Origination Form

Proposed Revisions to a Standard Plans Index

Originator:	Gibbs, Shae	Index Number:	711-001
Date:	6/18/2024	Sheet Number(s):	3
E-mail:	Shae.Gibbs@dot.state.fl.us	Index Title:	Pavement Markings

INDEX 711-001	SHEET 3 of 13
------------------	------------------

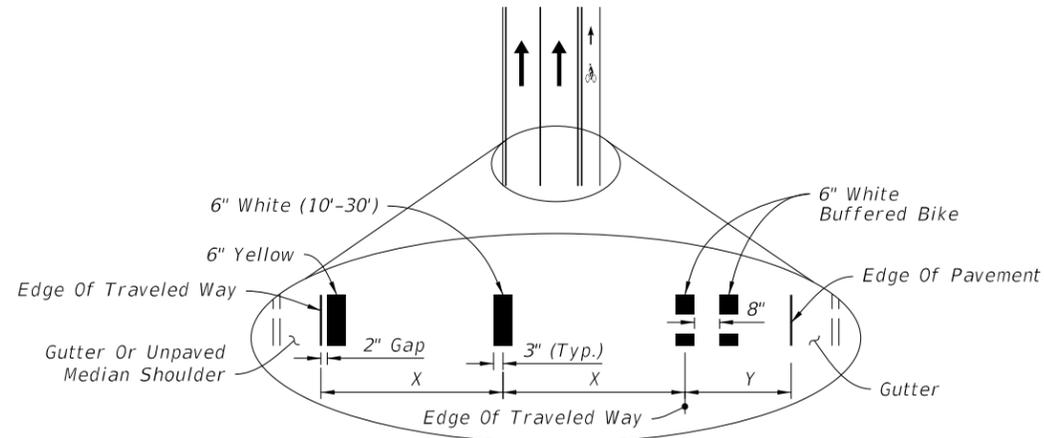
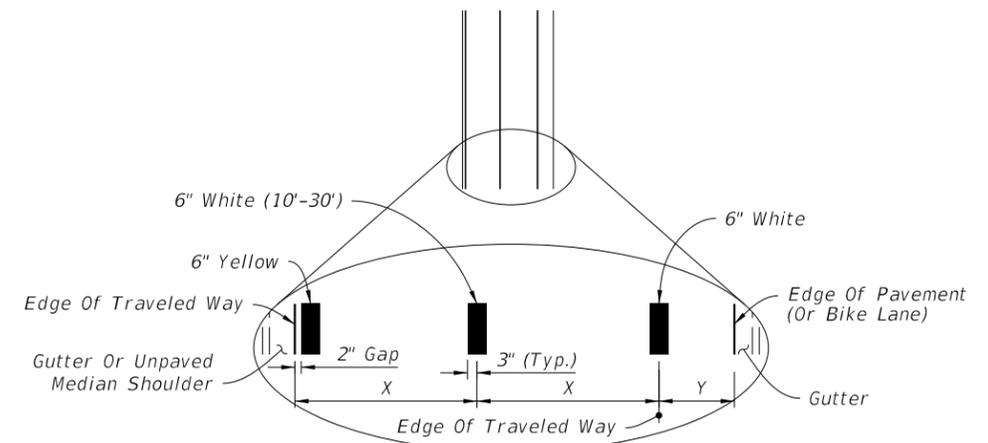
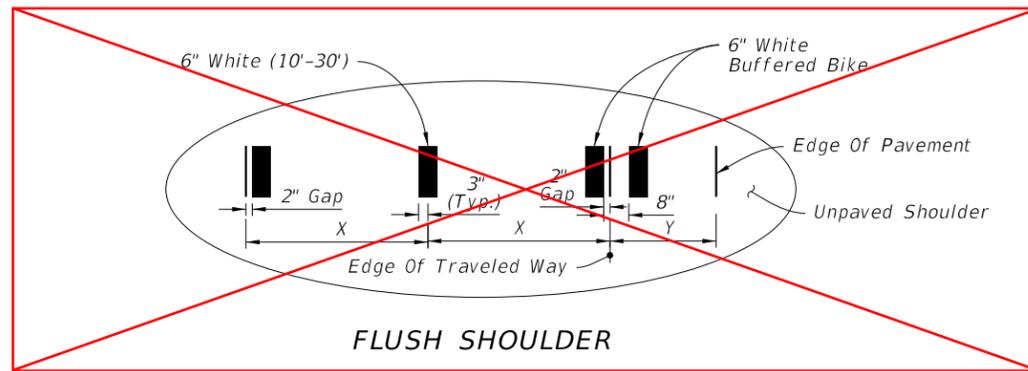
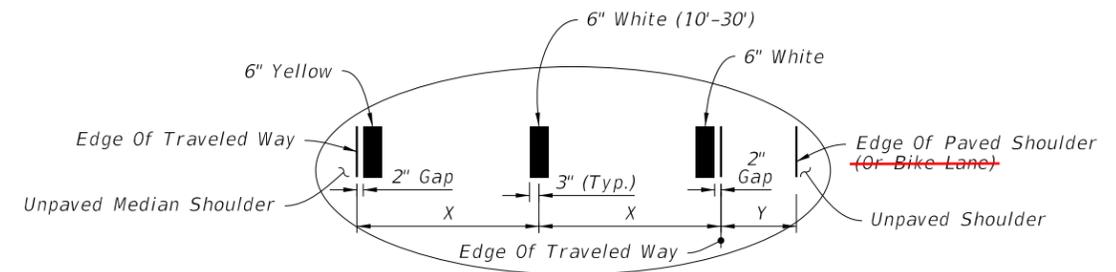
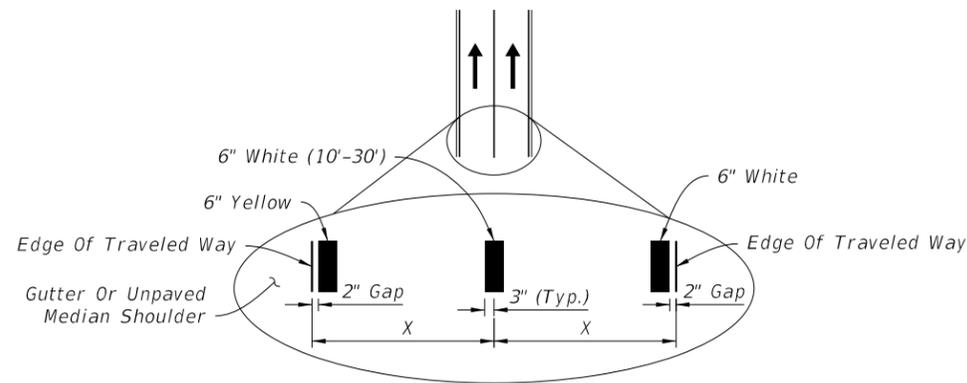
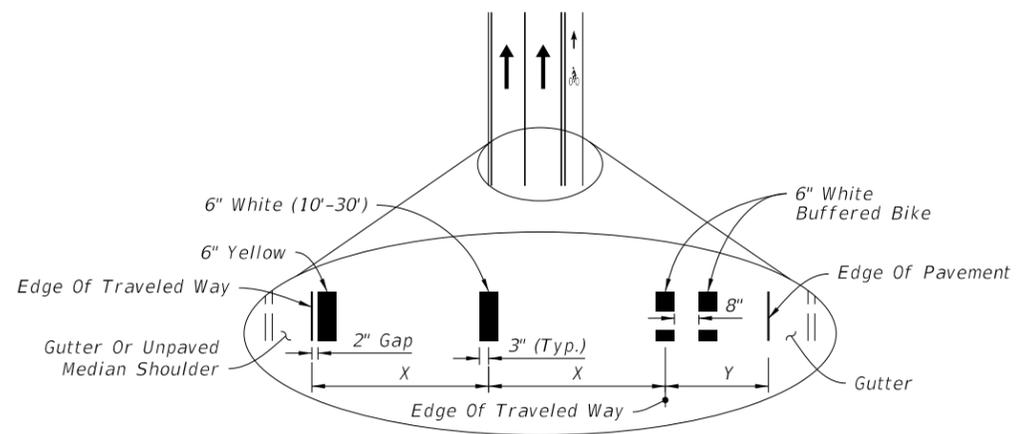
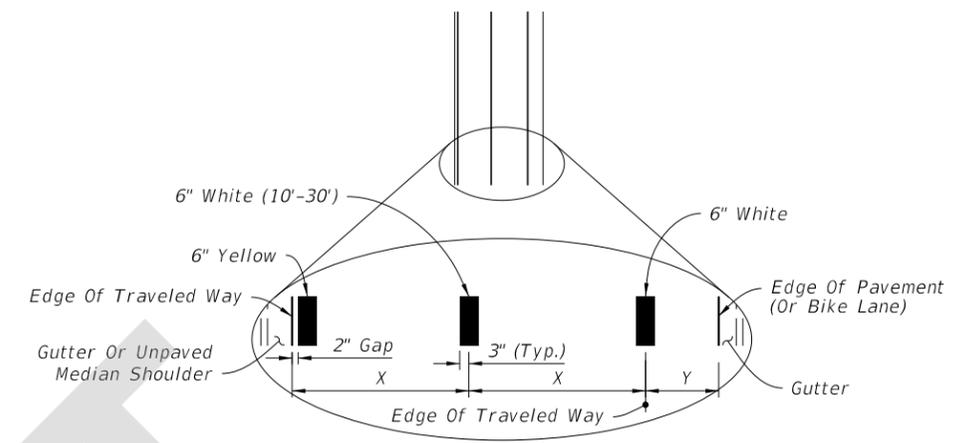
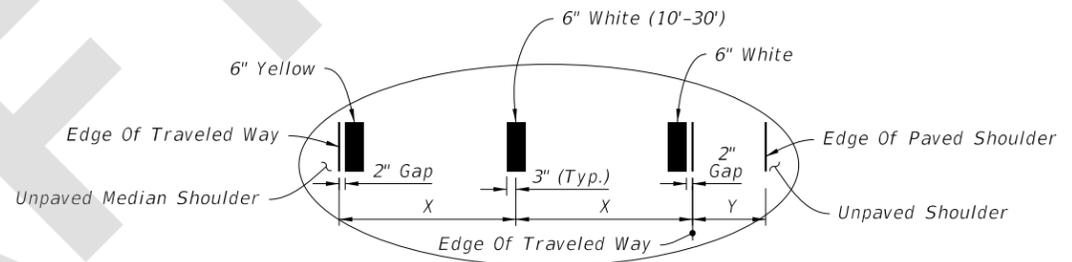
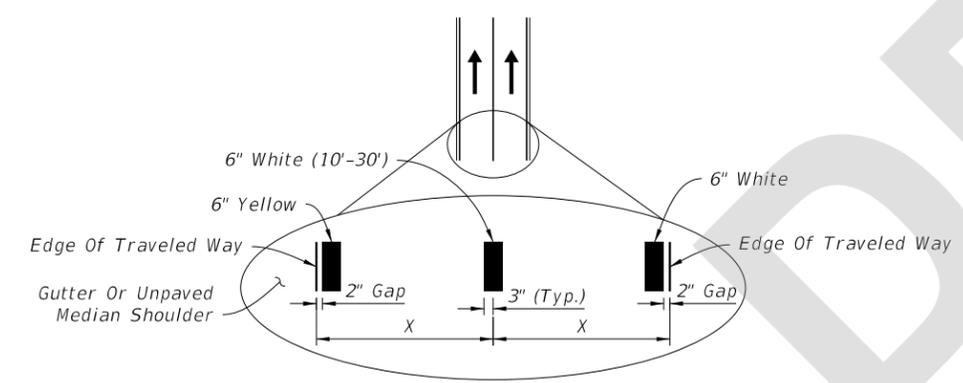
Sheet 3: Deleted Buffered Bike Lane Flush Shoulder detail

Paved Shoulders are no longer allowed to be marked as Bike Lanes per the new MUTCD 11th edition Section 9E.01
